**UNITED STATES ENVIRONMENTAL
PROTECTION AGENCY
REGION IX
75 Hawthorne Street
San Francisco, CA 94105**

**STATE OF HAWAII
DEPARTMENT OF HEALTH
P. O. BOX 3378
HONOLULU, HI 96801-3378**

March 16, 2020

Re: Response to Corrosion and Metal Fatigue Practices, Destructive Testing Results Report, Red Hill Bulk Fuel Storage Facility (Red Hill), Joint Base Pearl Harbor-Hickam, Oahu, Hawaii

Figure 1: Bulk and surface pH of concrete corresponding to the removed steel coupon plates. Bulk pH data and surface pH from DT Results Report [1].

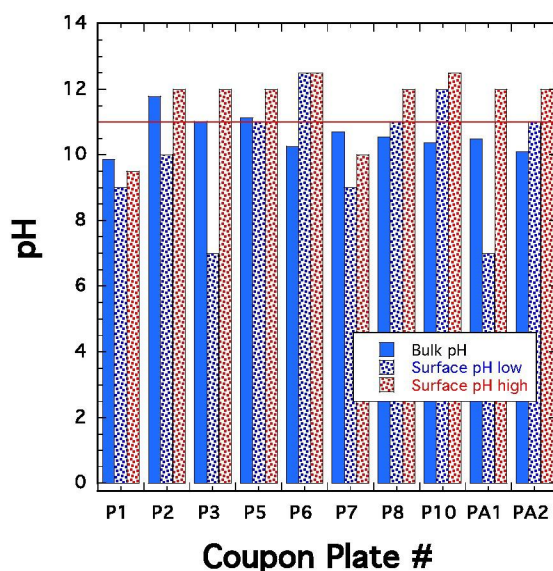
The alkalinity of pore solution in fresh cement and concrete is approximately pH 13 – pH 14 [4]. As the concrete ages, the alkalinity is maintained at the pH 12 - pH 13 level [5] until the calcium hydroxide is consumed by the carbonation reaction. Once the calcium hydroxide is consumed and calcium carbonate precipitates, the pH drops further to levels where imbedded steel can corrode [4, 5]. In non-carbonated, highly alkaline concrete, the corrosion rate of steel is extremely low [4]. When the pH of the concrete falls below approximately pH 11, however, such as by carbonation, corrosion rates begin to increase [7] and passivation is lost at approximately pH 10 [3, 5]. The plot of pH values (Figure 1) shows that many values dropped below pH 11, where plain-carbon steel begins to lose passivity and its corrosion rate begins to increase [3, 5, 7].

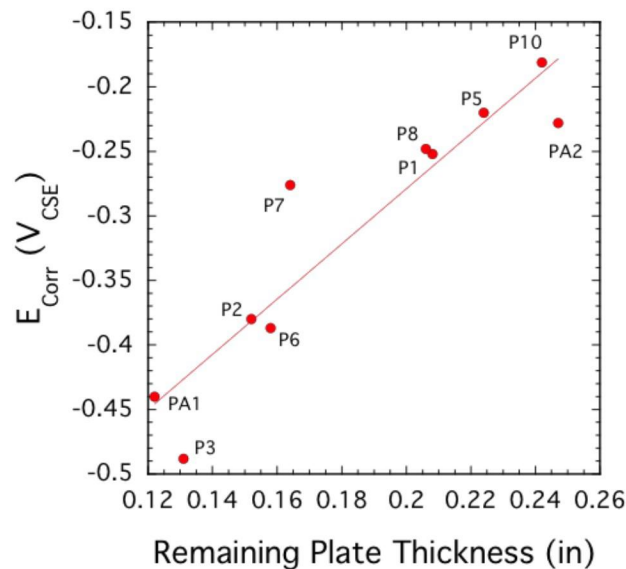
Of the potential measurements corresponding to the back side of the tank wall, only one potential was more positive than -0.2 V_{CSE}, indicating low probability of corrosion; five potentials were in the potential range of -0.20 to -0.35 V_{CSE}, indicating uncertainty of corrosion; and four potentials were more negative than -0.35 V_{CSE}, indicating high likelihood of corrosion. The reported minimum remaining plate thickness values for each plate was plotted vs the corrosion potentials (Figure 5), showing strong correlation. The more negative the corrosion potential (indicating a

higher tendency to corrode), the lower the measured remaining plate thickness. Plates P5, P10, and PA2 corresponding to the three most positive corrosion potentials ($> -0.23 \text{ V}_{\text{CSE}}$) showed no or only very light surface rust (Figure 6) [1]. Plates P1 and P8 (with potentials $\approx -0.25 \text{ V}_{\text{CSE}}$) showed mostly mild surface rust (Figure 6) [1]; whereas, the remaining plates PA1, P2, P3, P6, and P7 (with potentials $< -0.27 \text{ V}_{\text{CSE}}$) showed significantly more severe rusting (Figure 6) [1].

Figure 6: The back side of the steel coupons, structure-to-electrolyte corrosion potentials (in V_{CSE}), and the minimum remaining thickness (in inches) that was measured for each plate. From DT Results Report [1]

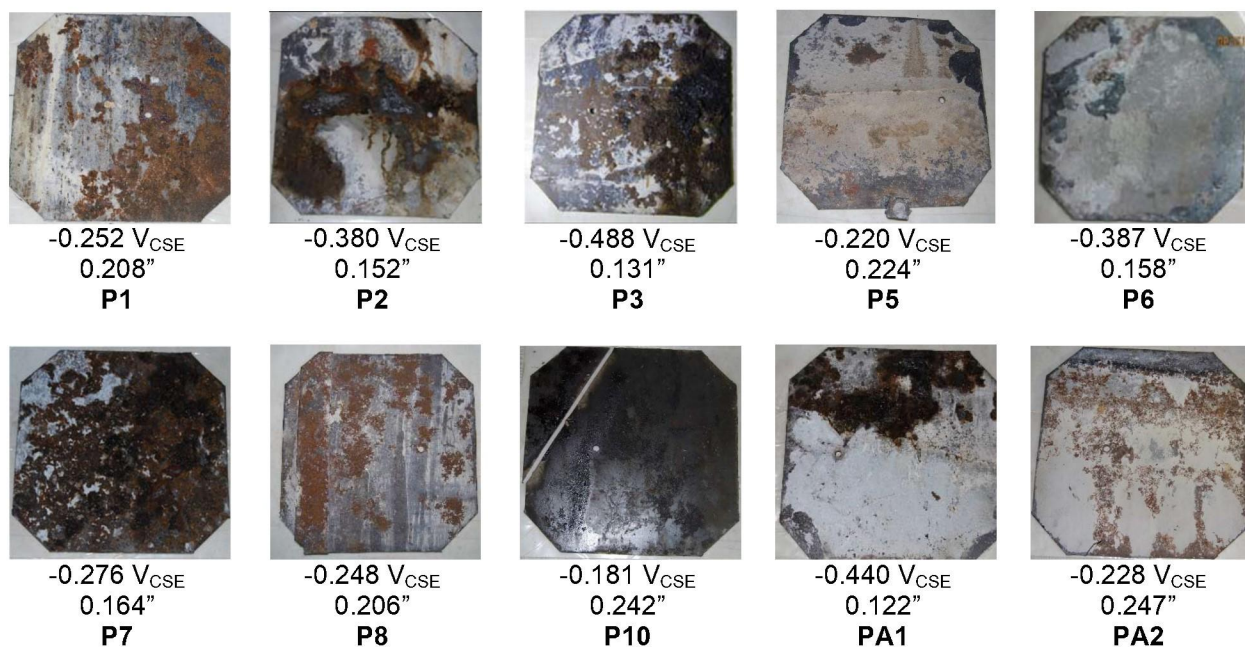
Generally, the formation of the visible red-brown rust (Figure 6) on plain-carbon steel indicates that the passivation in that local region has been lost. The gray regions of the plates (excluding the adhering concrete or grout) are regions where the steel is in the passive state (Figure 6). Passivation can be lost when the pH of the concrete drops below approximately pH 11 [7], or chloride (Cl) ions are present in sufficient concentration [4, 7]. The NACE Standard Practice SP0308-2008 [9] indicates that acid-soluble chlorides in excess of approximately 0.2 % (by weight of cement) can initiate corrosion of steel in concrete. The ion chromatography analyses of the concrete powder samples showed that the chloride concentration in the concrete ranged from 50 ppm (0.005 % by weight of cement) to 171 ppm (0.017 wt%), which is much lower than the threshold. The concentration of chlorides detected in the corrosion

products using energy dispersive X-ray analyses (EDXA), however, was significantly higher: The maximum value of 1.7 wt% (17,000 ppm by weight of corrosion product) was detected in the corrosion product of plate PA1; 0.6 wt% (6,000 ppm) in plates P2 and P7; 0.3 wt% (3,000 ppm) in plates P3, P5, P6, and P10; and none in plates P1, P8, and PA2. The detection limit of EDXA is on the order of 0.1 wt% (1,000 ppm). The maximum concentration of the chlorides in the corrosion products were up to approximately 100 times higher than the maximum concentration in the concrete. Chlorides at these levels as well as the drop in concrete alkalinity below approximately pH 11 are likely to breakdown passivation and cause increasing corrosion rates of the steel.

Figure 8: Effect of initiation phase on average corrosion rates (a). Remaining life (b) based on active and average corrosion rates and pit depth 1 (PD1).

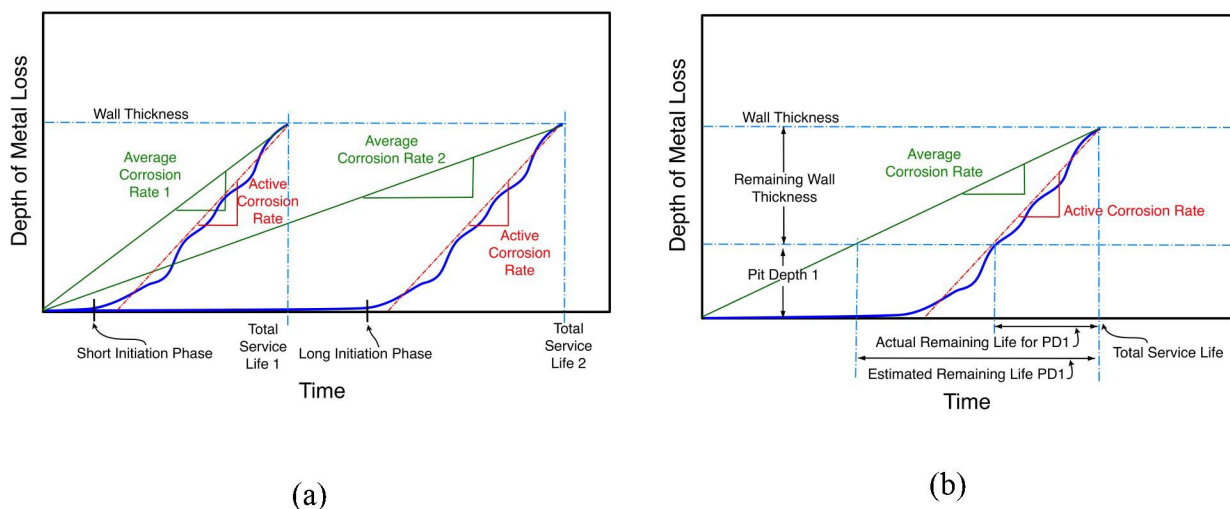
The higher historical corrosion rates could be associated with short initiation phases (Figure 8a) from regions where steel lost passivation in the early stages. Regions where the steel remain passivated and have long initiation phases (Figure 8a) will result in low average corrosion rates. Currently, any region of the tank that has back-side corrosion (i.e., rusting and remaining thickness less than the original plate thickness of 0.25") is likely not passivated, and in the propagation stage (Figure 7). To obtain an accurate remaining life before wall penetration, realistic corrosion rates are needed. Therefore, in regions of the tank that are no longer passivated, actual measured active corrosion rates or historical corrosion rate data with a short initiation phases (Figure 8a) are needed to more accurately estimate the remaining life

(Figure 8b). If corrosion rates based on long initiation phases are used, the actual remaining life could be grossly over estimated (Figure 8b).

Figure 11: Cross section of coupon plate P3 (a) at the area of maximum wall loss (p. 18 of DT Results Report [1]) out of four sections examined, and cross section of coupon plate P6 (b) at area of maximum wall loss out of three sections examined (p. 24 of DT Results Report [1])

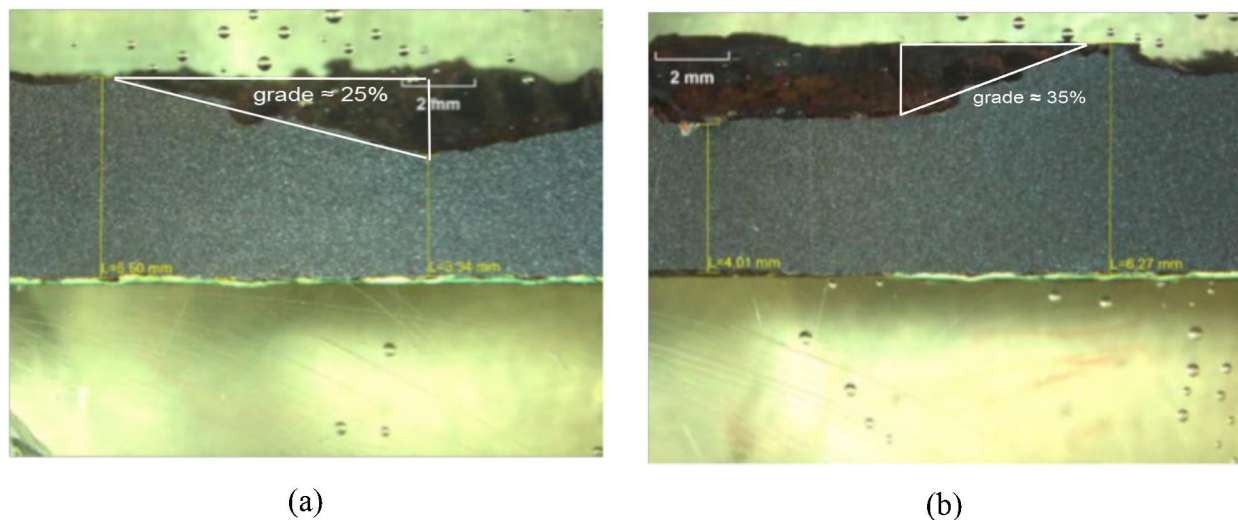
For coupon plates P3 and P6, a remaining thickness less than 0.200" was not expected (pp. 46 and 51 of DT Results Report [1]); however, the destructive testing showed minimum remaining thicknesses of 0.131" and 0.158", respectively, for coupon plates P3 and P6. The pit size and grade (Figure 11) were well within the detectable limits of the low frequency electromagnetic technique (LFET) [16], but these pits were not recorded. The DT Results Report [1] also showed that there were high levels of magnetite in the corrosion products ranging from 17 % to 84 wt% (Table 3). It has been reported in the literature [17] that when

Figure 12: Coupon plate P2. Possible deep pit in yellow box region not sampled. Original images from DT Results Report [1].

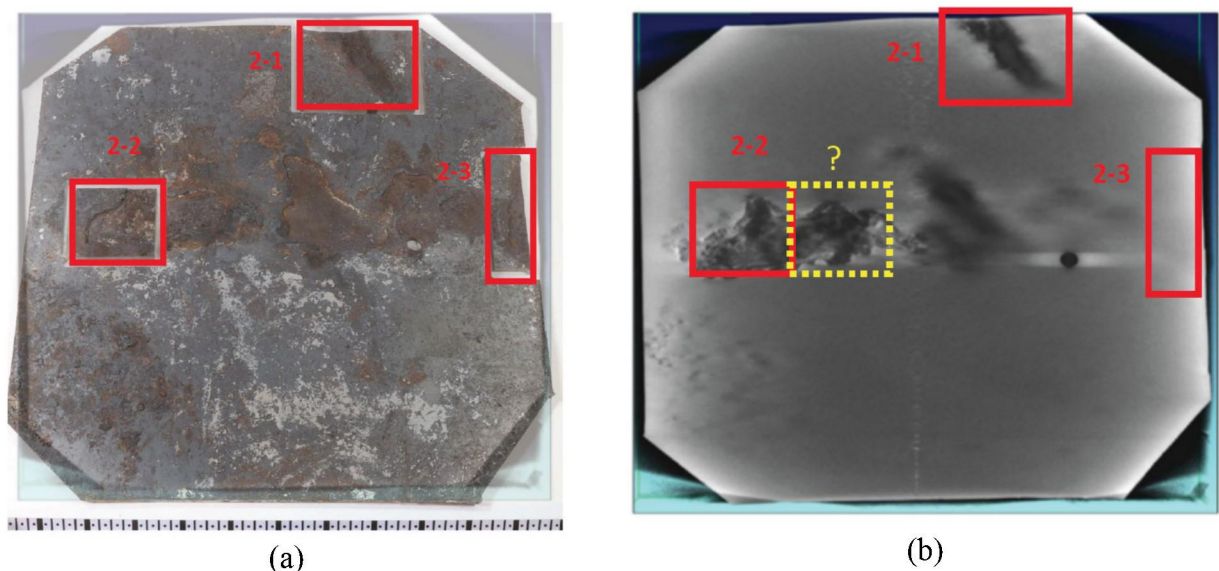
There are also concerns of whether or not the sites with the deepest pits were sampled during the destructive testing. The steel coupons were specified to be cleaned and subjected to three-dimensional profilometry (as specified on p. 8 of the DT Results Report, [1]) to document the

surface profile of the remaining steel substrate. The steel coupons were cleaned with a CO₂ dry ice blast, but all of the corrosion products were not removed; hence, the regions of the deepest pits would be difficult to determine. The three-dimensional profilometry data was not provided in the DT Results Report [1], but the results would likely not have characterized the bare steel substrate since the corrosion products were not thoroughly removed. X-ray computed tomography (CT) was used to aid in selecting the regions with the deepest pits, but in some cases, regions with potential deep pits were apparently not sampled (e.g., Figures 12, 13, and 14). The DT Results Report [1] did not describe if other methods were used to confirm the location of the deepest pits.

Figure 1 – Destructive Testing Cross-section from Sample 6-1

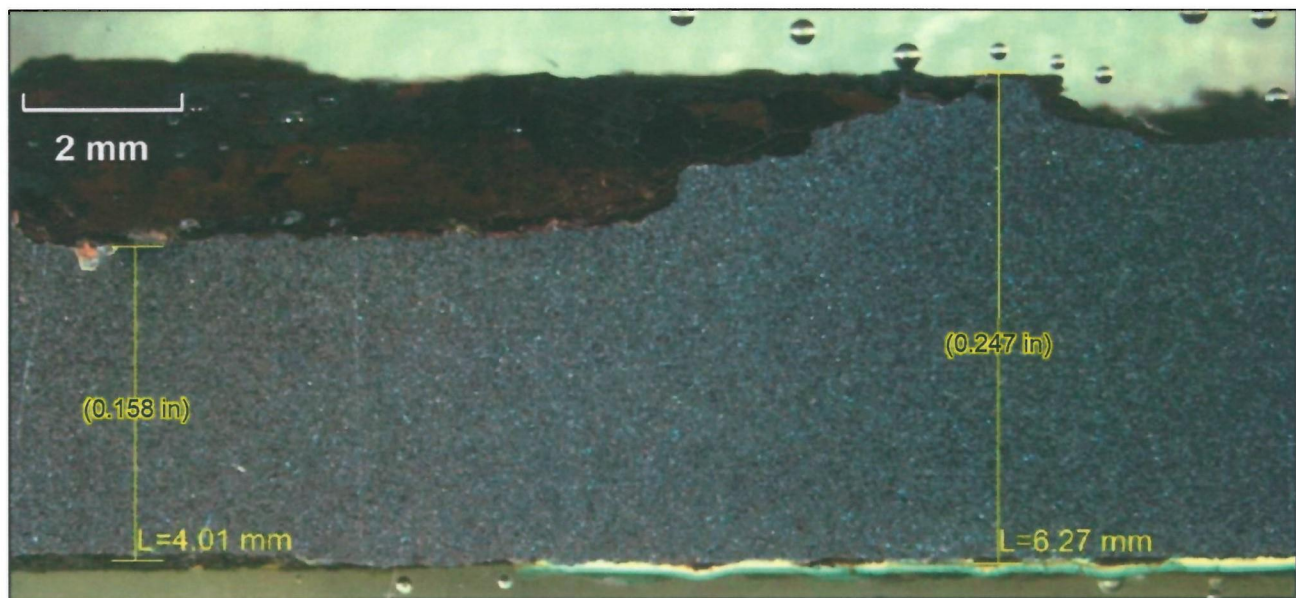
1. The larger, TesTex Falcon Mark II 2000 device should have been able to detect the pit in Coupon 6. According to the Navy this device has a probability of detection (POD) of 100% at 25% wall loss on pits with an aspect ratio of 3:1. The deepest pit in Coupon 6 amounted to ~37% wall loss and aspect ratio of greater than 3:1 (width to depth ratio). Figure 1 shows the cross-section through the deepest pit in Coupon 6 where the size and depth of the pit is obvious.
2. The smaller, TesTex TS-2000 device should have been able to detect the pit in Coupon 6 as the Navy stated this device can detect pits with a diameter of 1.57 mm. The width of the corrosion pit in Coupon 6 was much, much wider than 1.57 mm as is shown in Figure 1.

Second, the BWS believes Figure 1 clearly demonstrates this pit cannot be described as a “*pit of very small volume.*” This figure clearly shows a broad pit of considerable volume.

A similar figure was provided for Coupon 6 in Figure 1. The Navy's LFET and PAUT entirely missed the backside corrosion on Coupon 6, but the DT showed the minimum wall to be 0.158 inches thick. That is, DT demonstrated that this location should have been repaired, whereas both the LFET and PAUT NDE techniques indicated that the liner in this area was thicker than 0.200 inches.

Figure 2 -- (Image from: IMR Test Labs. 2018)

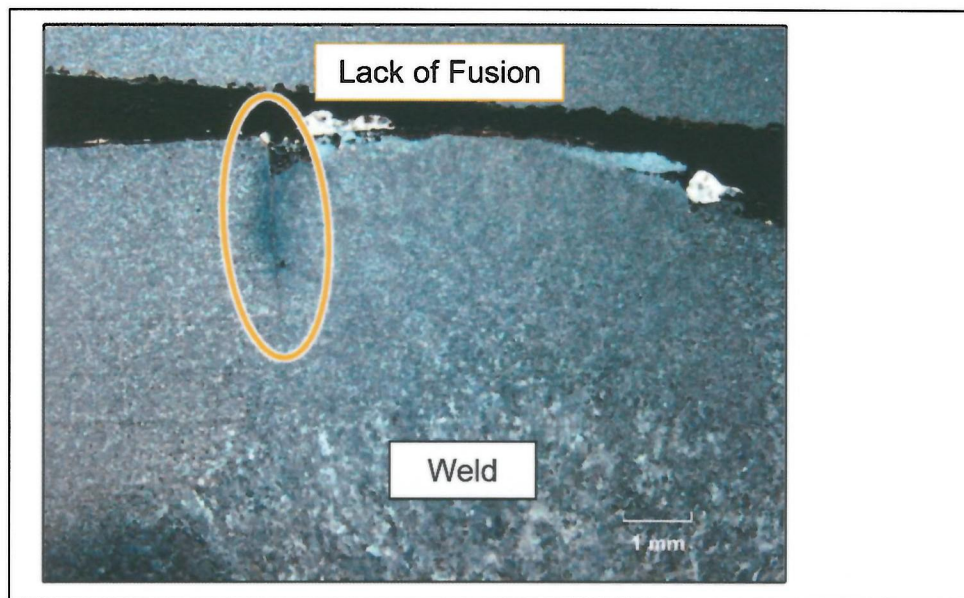
4. The DT inspection did find weld defects. The one coupon that actually had a weld contained a linear defect that was found by destructive testing. This lack of fusion linear weld defect is shown below.

Figure 4 – Relationship between NDE thickness estimate prior to DT and the actual remaining thickness determined from DT.

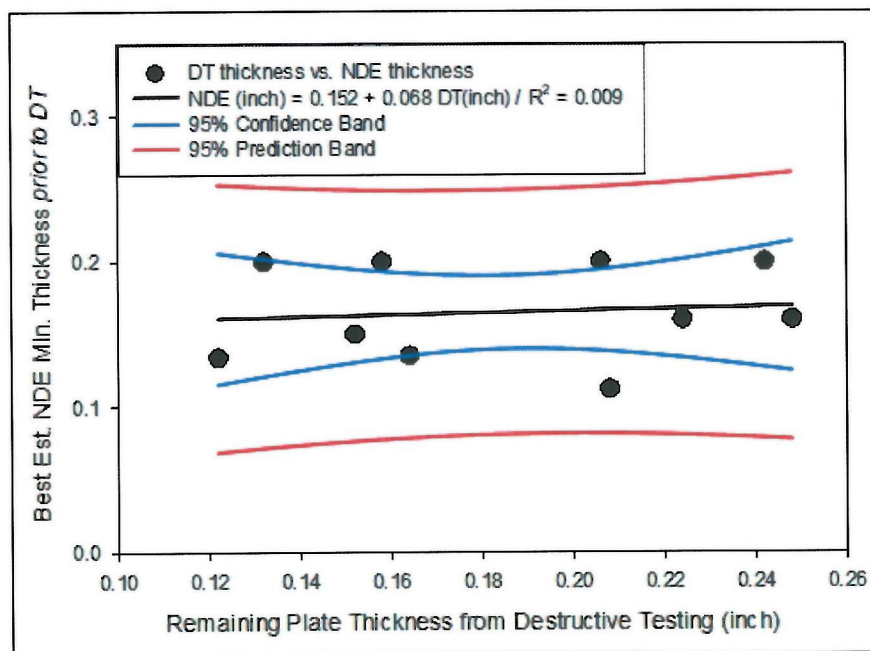
Figure 4 clearly indicates the NDE techniques are neither accurate nor reliable. First, the slope (0.068) of the line drawn through the DT vs NDE data is very flat (close to zero), indicating the NDE results are essentially insensitive to actual corrosion depth. For comparison, if NDE was perfectly accurate, then the DT thickness would be equal to the NDE thickness and the slope of the line drawn through the data would be 1.0. Instead, the calculated slope is consistent with what one would expect if the NDE results were simply chosen at random without regard to the actual coupon thickness. Another indication is the coefficient of determination (R^2), which measures NDE accuracy by comparing the variation in NDE results to the residual variation after accounting for the actual coupon thickness (using the regression line). As noted in Figure 4, the R^2 value is effectively zero (0.009), indicating none of the observed variation in NDE-measured thickness is attributable to corresponding variation in the actual thickness of the test coupons.

Finally, the figure includes plots of the 95% lower and upper prediction bands, which are very broad. For example, for a coupon with an actual remaining wall thickness of 0.12 inch, with 95% probability the corresponding NDE-measured thickness will fall between 0.070 and 0.25 inch (the values at which the lower and upper bands, respectively, intersect the vertical line at 0.12 inch). The bands vary little over the range of coupon thickness studied. Thus, for any actual tank wall thickness, the NDE-measured thickness can be reasonably expected to range from effectively no damage to severe damage.

Figure 5 – Destructive Testing Cross-section from Sample 3-3.

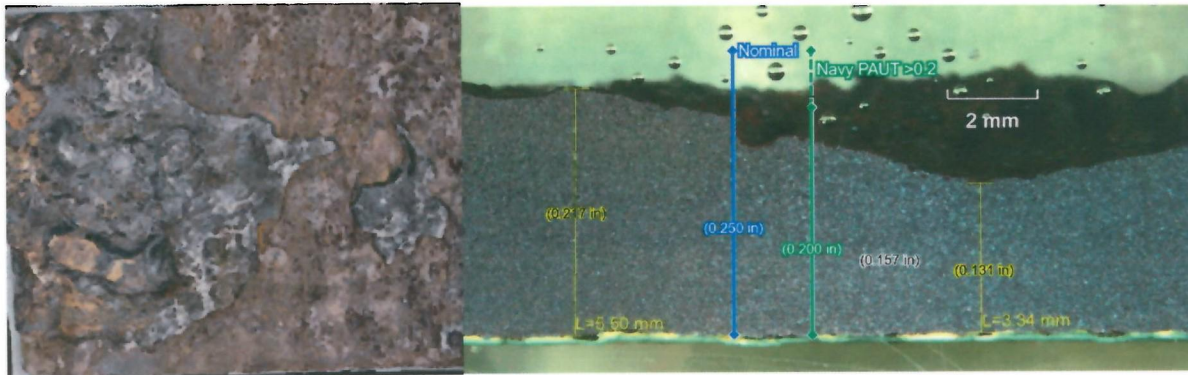
A more graphic illustration of the error in the NDE methodology is shown in Figure 5. The image on the left-hand side of Figure 5 shows the extensive backside corrosion on Coupon 3. The right-hand side of Figure 5 shows the plate's reported thinnest area in cross-section after destructively testing. While it is unclear from the DT and IMR reports, this thinned region

(0.131-inch-thick) was presumably located by CT scanning of the entire coupon. The Navy NDE predicted that this area had little to no backside corrosion.

The thin blue-green layer on the bottom of the plate on the right-hand side of Figure 5 is the paint on the fuel wetted side of the steel liner. The blue line shows the full plate thickness of 0.250 inches. The yellow line on the left side is the actual maximum plate thickness which shows 0.217 inches thickness indicating general corrosion thinning and deeper corrosion over the back side of this steel coupon. The green line shows the thickness the PAUT found, i.e., > 0.200 inches (LFET found a remaining wall of 0.033 inches but the supposedly more accurate PAUT indicated the plate was much thicker). The actual minimum thickness found by DT was 0.131-inches as shown by the yellow line on the right side. This variation in the lengths of the colored lines illustrates how large the difference can be between the various NDE inspection techniques and the actual depth of corrosion. In this case, LFET indicated the plate was very thin, the PAUT prove-up indicated little-to-no corrosion, and the DT indicated that this location was sufficiently thinned that repair should have been triggered.

Figure A-5. The same area is shown in an image provided prior to shipping Coupon #7 to IMR (provided to IMR on March 13, 2019). What appeared to be a deep corrosion pit was actually rust-colored staining of the edge surface

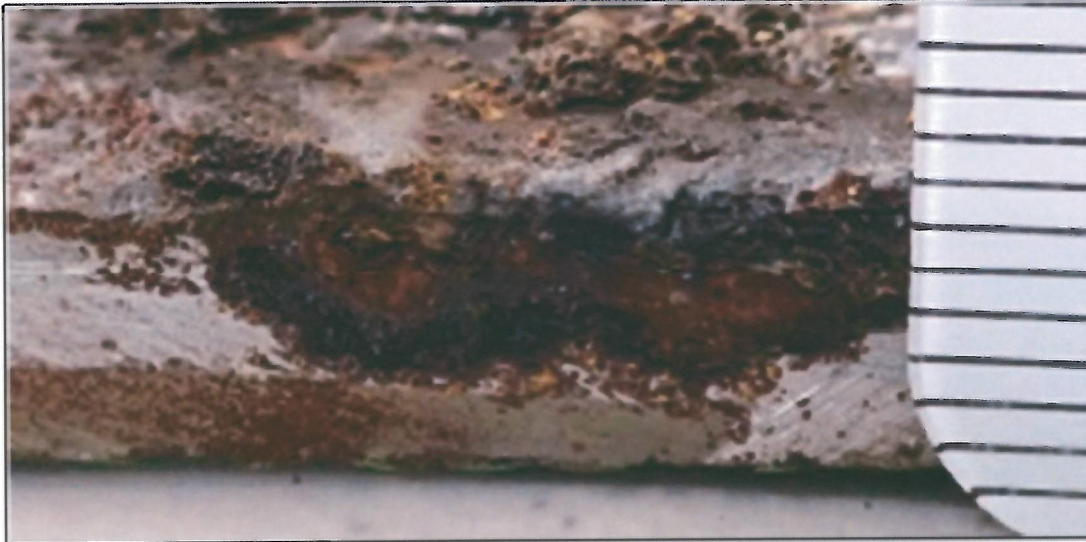
Following the initial issue of IMR on December 17, 2018, the Navy asked IMR to further investigate the corrosion seen on the edge on the remains of Coupon #7. IMR used CO₂ cleaning of the test sample edge. These results are provided in Appendix A of the IMR revised report. Figures A-4 and A-5 of the IMR revised report are included below to show the area of concern. The revised report Appendix A concludes:

1. There was pitting observed as shown in their Figure A-4
2. It is not surprising that corrosion was not found as this area had been sandblasted.
3. The explanation that the area of concern "had been superficially altered by heat associated with sectioning or some other post-sectioning reaction (atmospheric corrosion or corrosive media attack)" is not credible. Atmospheric corrosion would be uniformly distributed along the cut surface, but the area of concern is localized. Secondly, the porosity is not consistent with heat associated with sectioning. Finally, we are unaware of any corrosive media used during coupon removal that could have locally attacked the edge in the area of concern.
